March 5, 2009

Subject: UniStar Nuclear Energy, NRC Docket No. 52-016  
Calvert Cliffs Nuclear Power Plant, Unit 3  
Environmental RAIs No. 1001 through 1011

The purpose of this letter is to respond to the requests for additional information (RAIs) identified in the NRC letter to UniStar dated February 3, 2009 (Reference 1). The RAIs address figures needed to publish the environmental impact statement (EIS) and information necessary for completion of regulatory reviews.

Figure 2.3-68 - CCNPP Water Production Wells

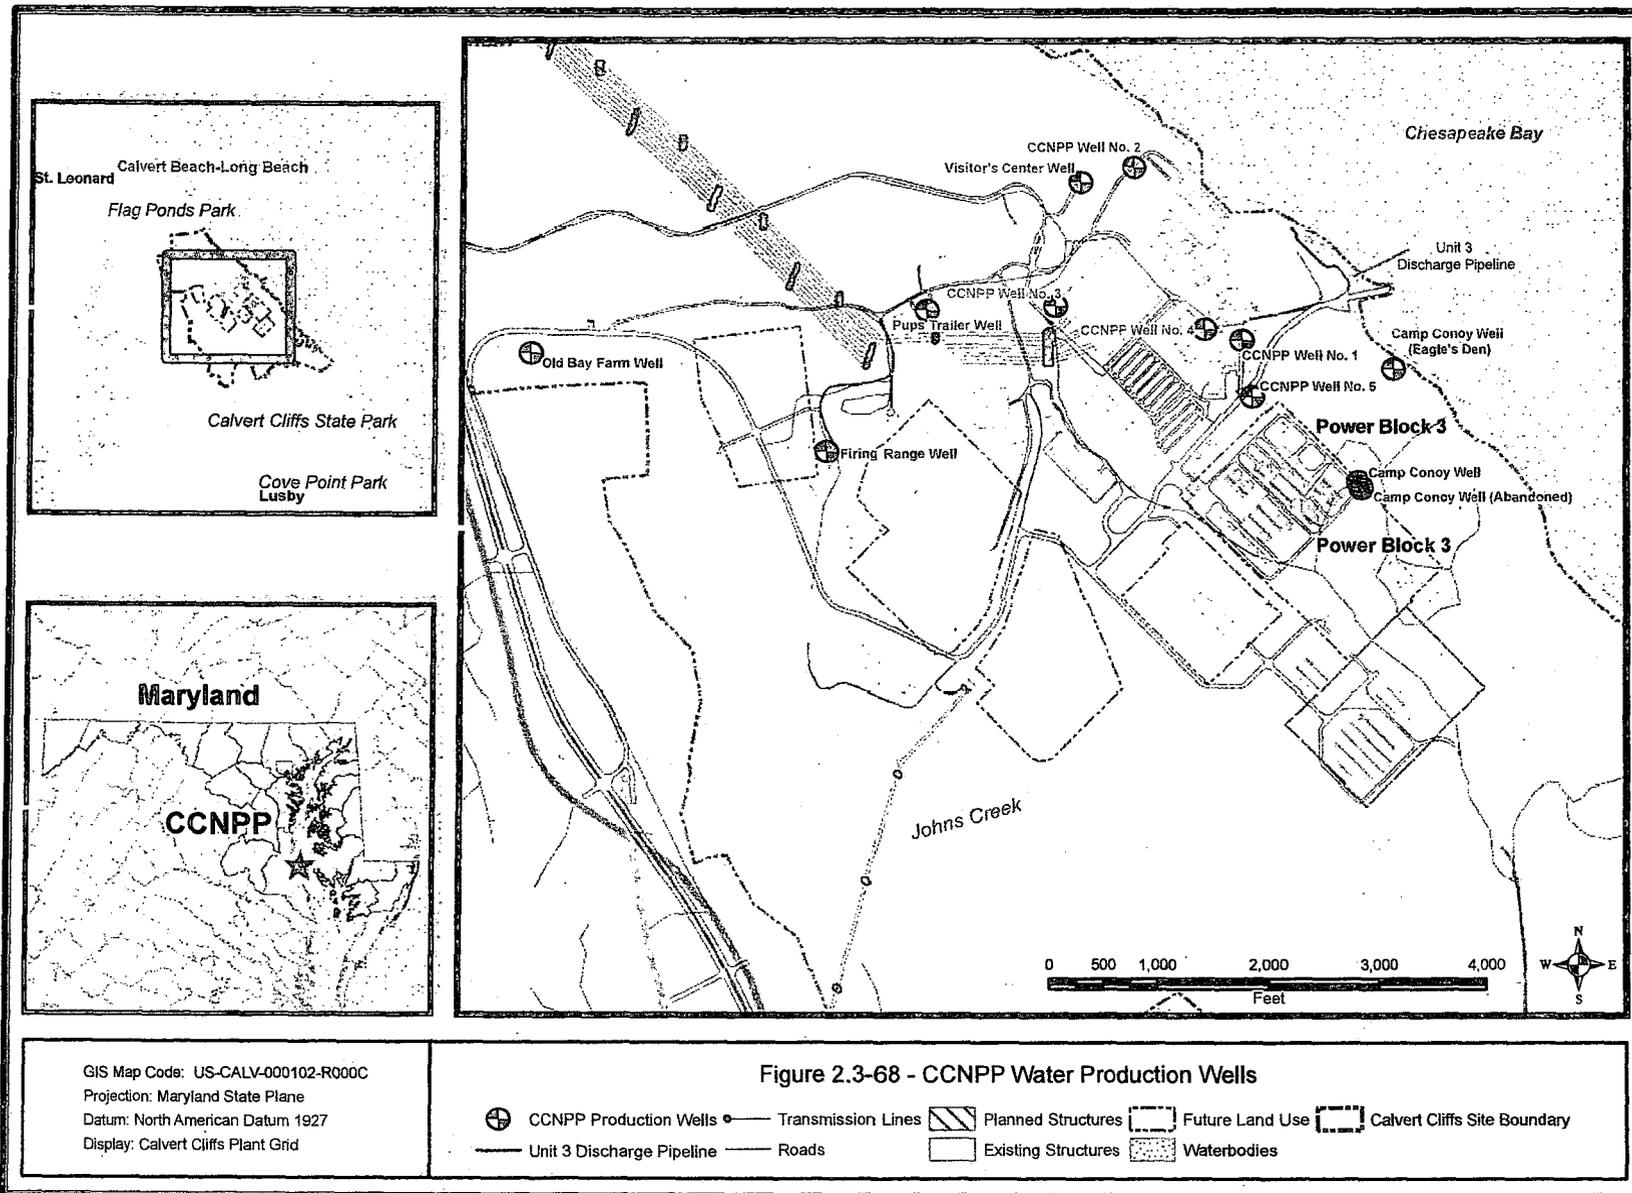
Provide legible graphics or GIS data for ER Figure 2.3-68.

No changes to the COLA are required.

**FIGURE 2.5-1** **Rev. 0**  
 CCNPP SITE 50 mi  
 (80 km) VICINITY  
 CCNPP UNIT 3 ER

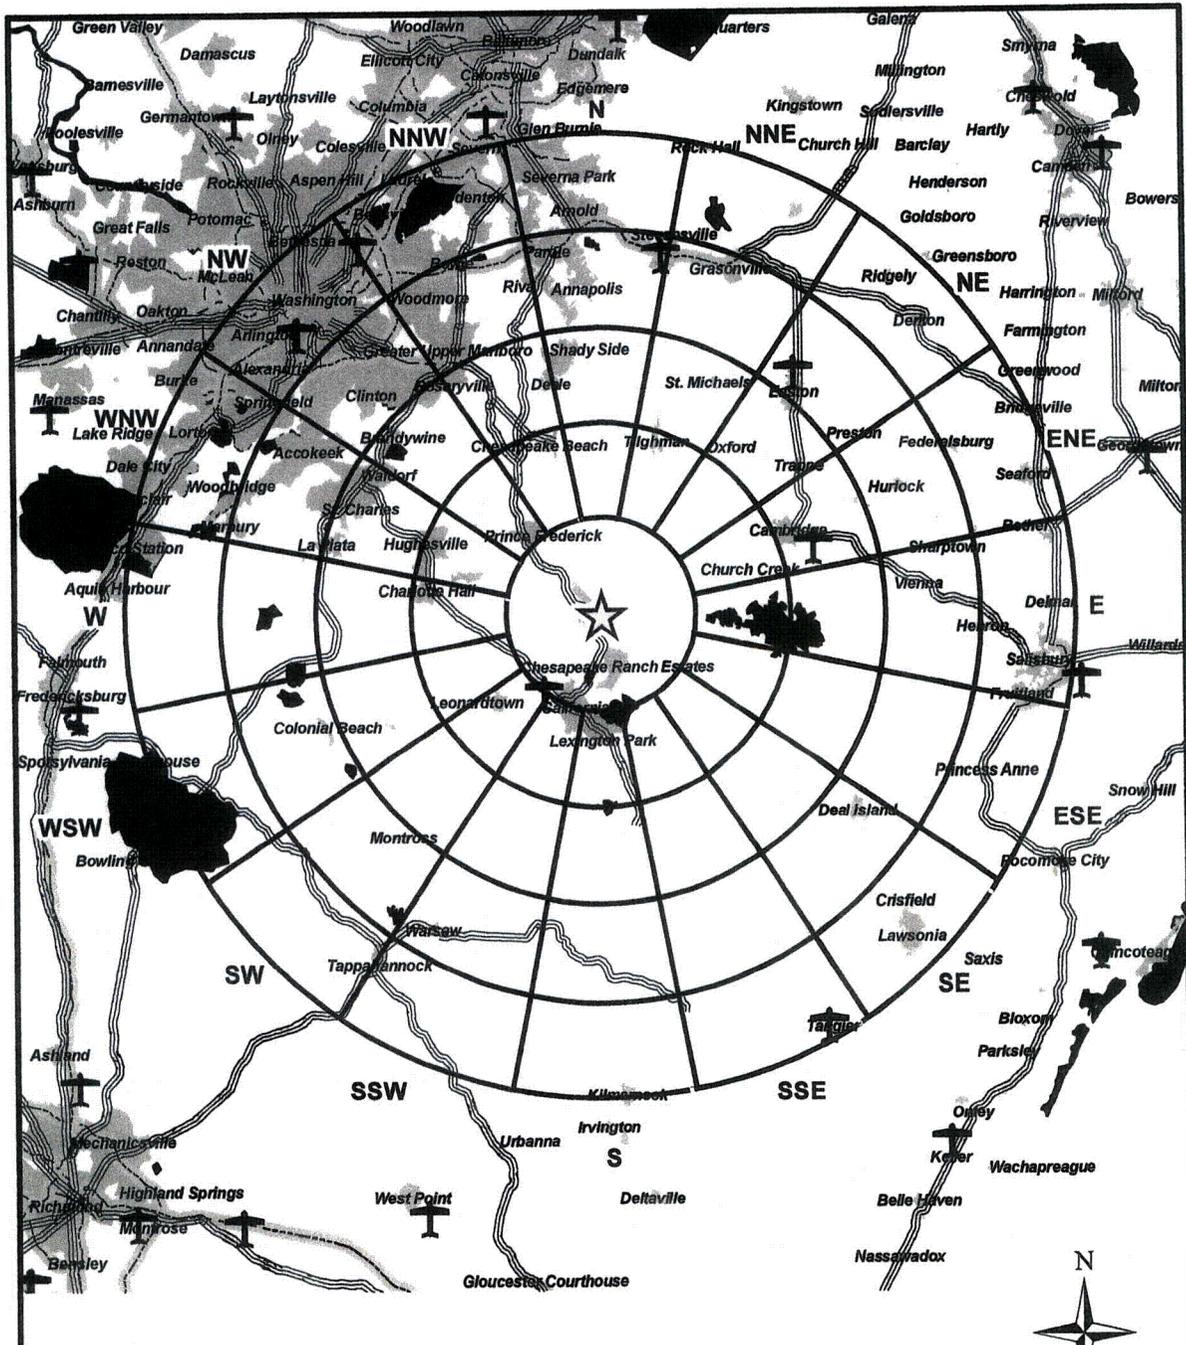
Provide legible graphics or GIS data for ER Figure 2.5-1.

UniStar has prepared a figure for use in the printed version of the EIS. See attached figure.

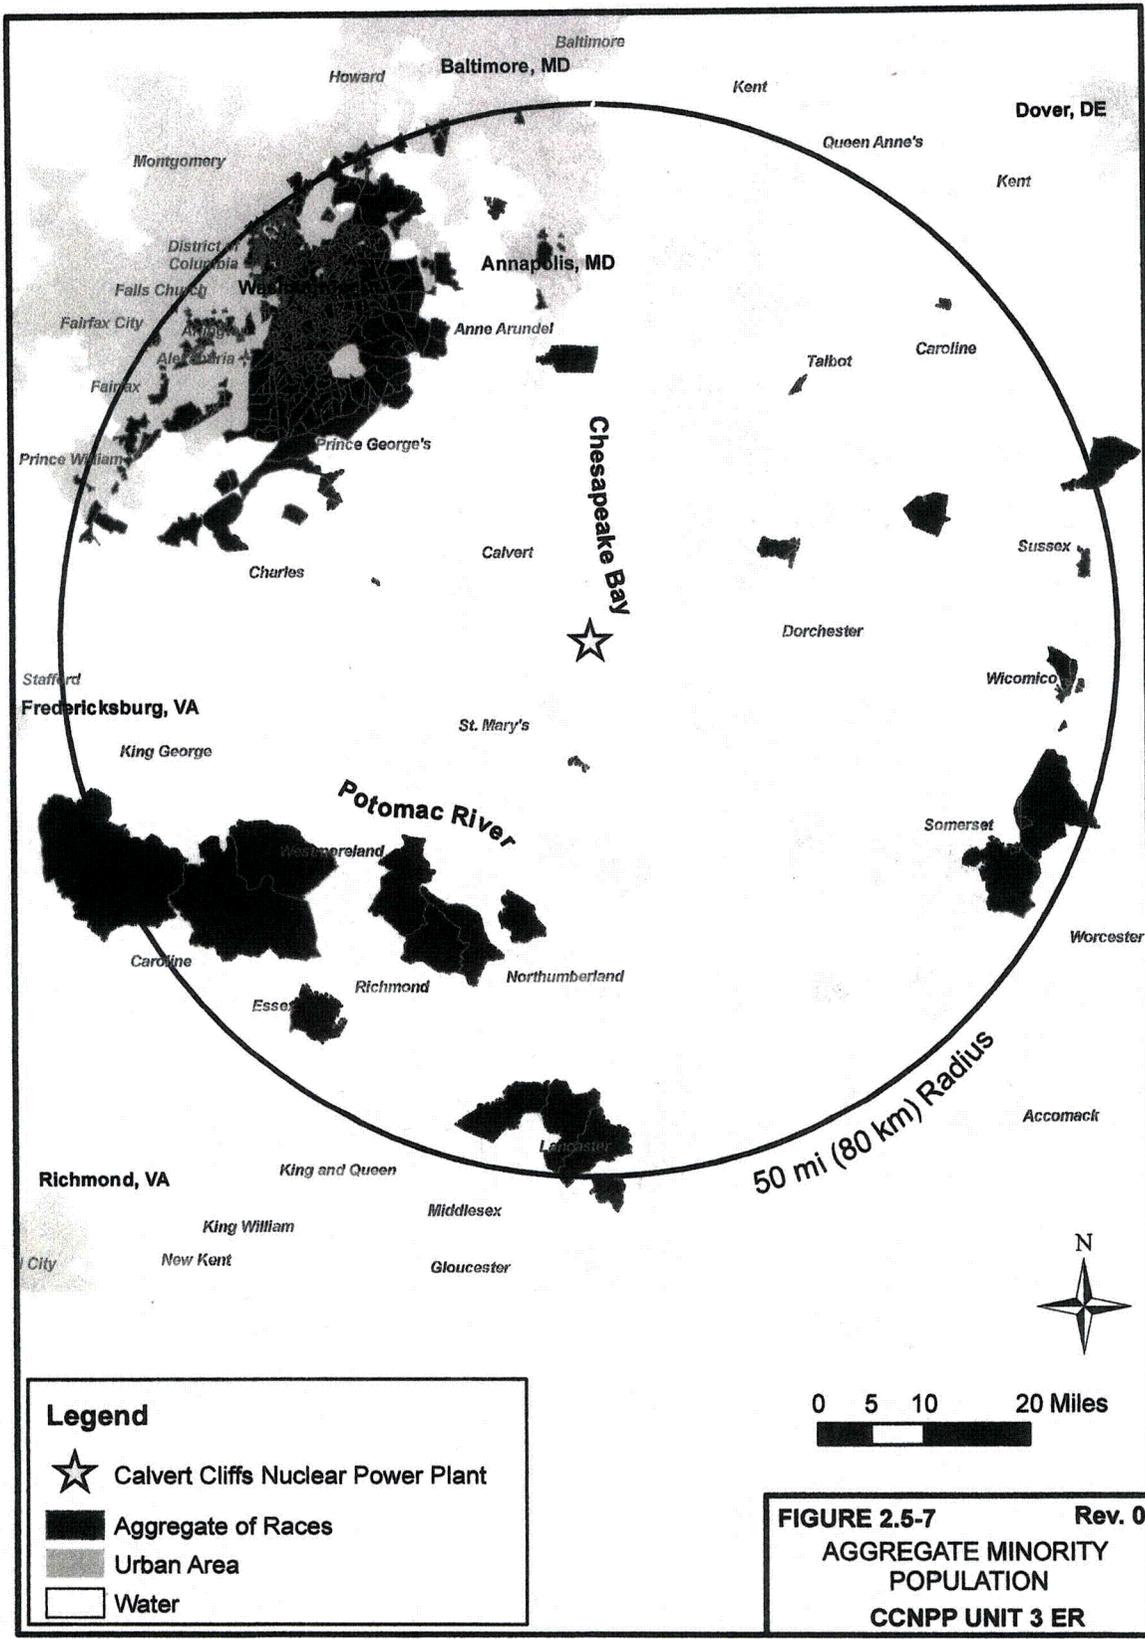
Provide legible graphics or GIS data for ER Figure 2.5-7.

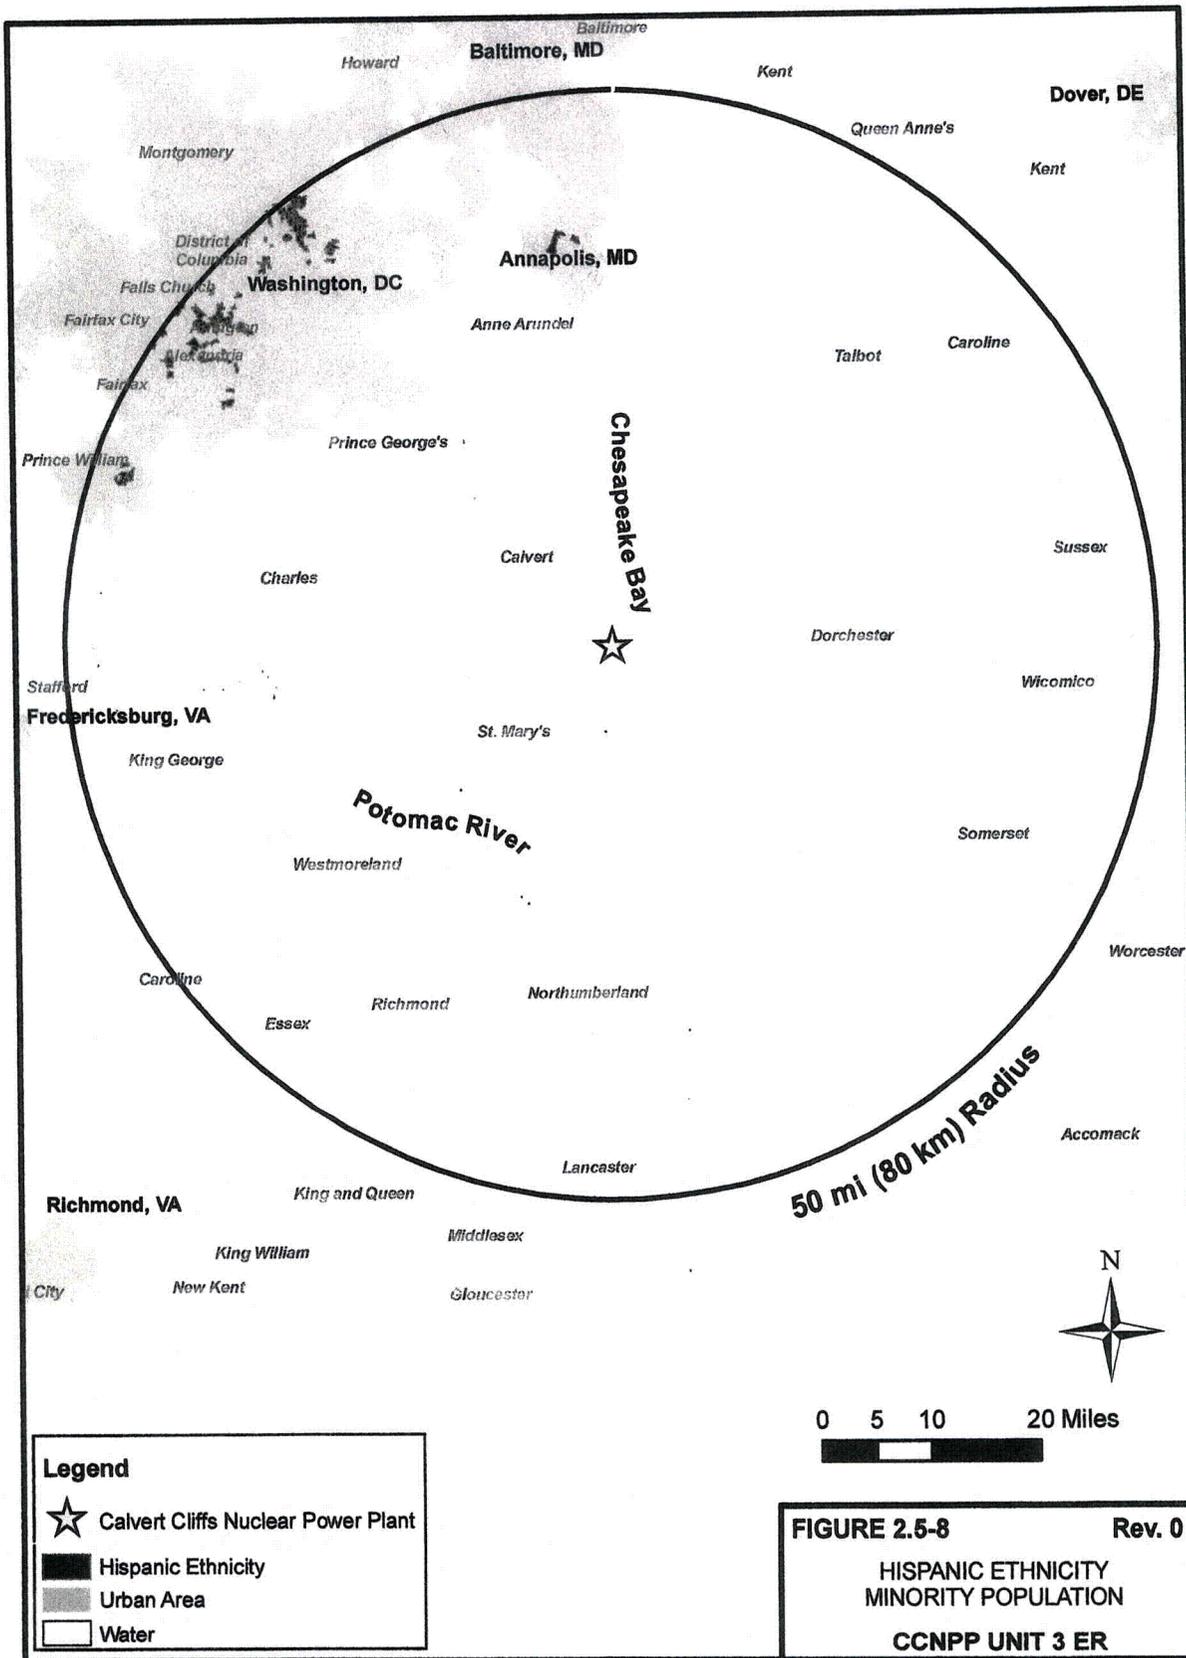
Provide legible graphics or GIS data for ER Figure 2.5-8.

UniStar has prepared a figure for use in the printed version of the EIS. See attached figure.

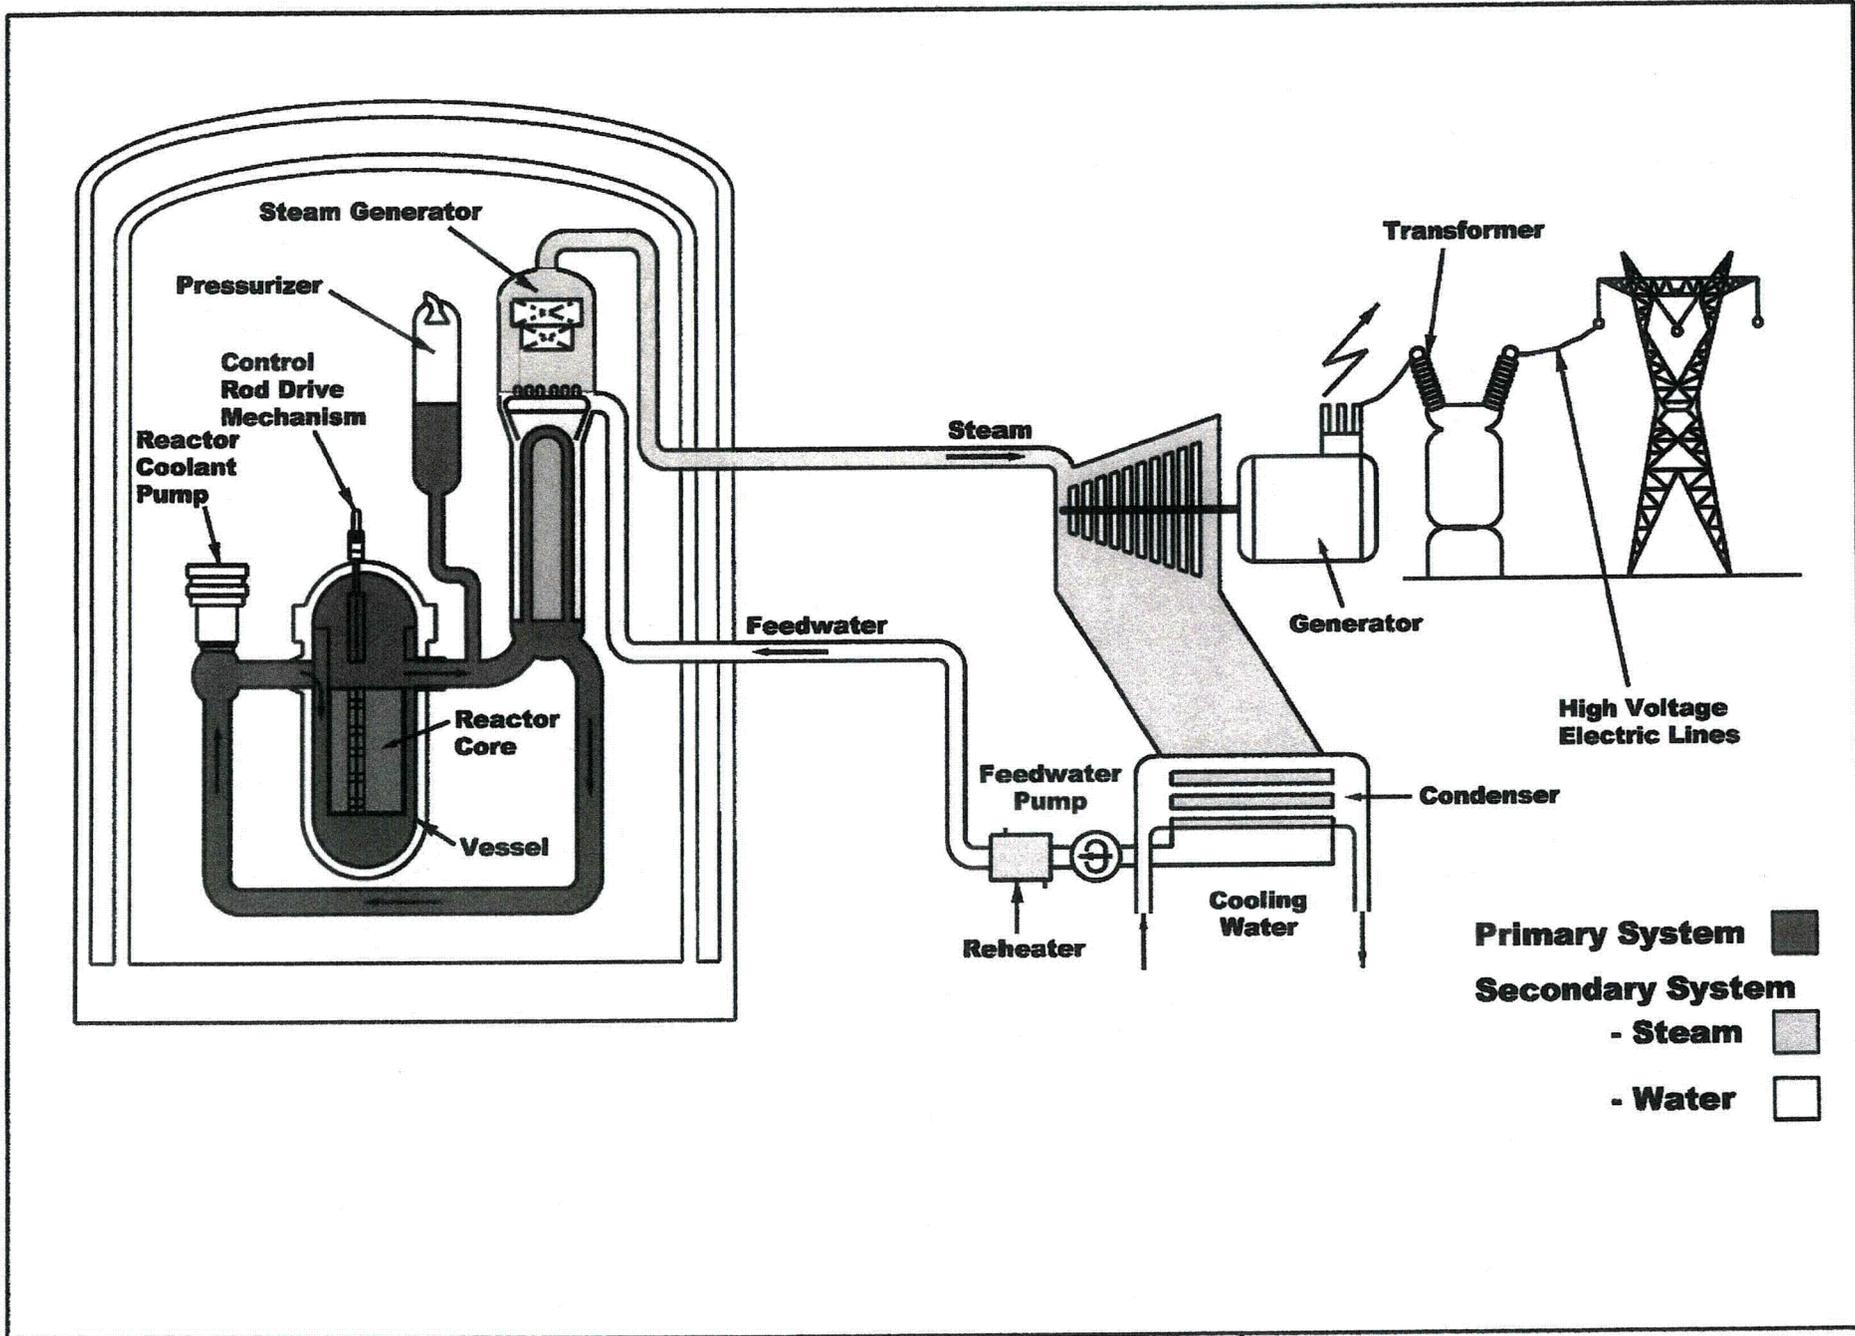
Provide legible graphics or GIS data for ER Figure 3.2-1.

UniStar has prepared a figure for use in the printed version of the EIS. See attached figure.
